Wanhao D7 Correction on 20th Feb 2017
D7 V1.1 to be released on 1st March 2017

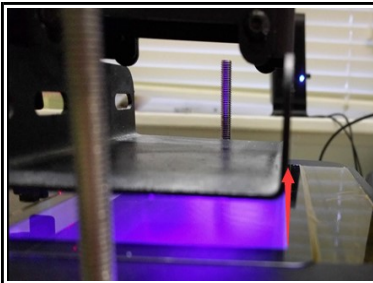
D7 Version 1 issue		D7 Version 1.1 improvement	
Pic	issue	Pic	Improvement
	<p>1</p> <p>There's no protection between the hood and the printer. So it leaves scratches on the printer during shipping</p>		<p>1</p> <p>By adding the RUBBER protector and 2 foam binding to secure the hood from moving during shipping. So there's no scratches anymore.</p>
	<p>2</p> <p>There's no end stop cover for Z axis MAX, So the platform could move out of Z axis from top.</p>		<p>2</p> <p>1. Set the software maximal 200mm for Z axis. 2. By adding top stop cover to stop the platform from moving out of track.</p>
	<p>3</p> <p>The Power Cord is set on top of hood which may punch a mark on hood.</p>		<p>3</p> <p>To put the cord inside the hood to avoid the punch possibility</p>
	<p>4</p> <p>The FEP being pushed broken during shipping.</p>		<p>4</p> <p>To add 2pcs 3mm Foam between the VAT and the Printer Body. So most impact would be absorbed by the foam.</p>
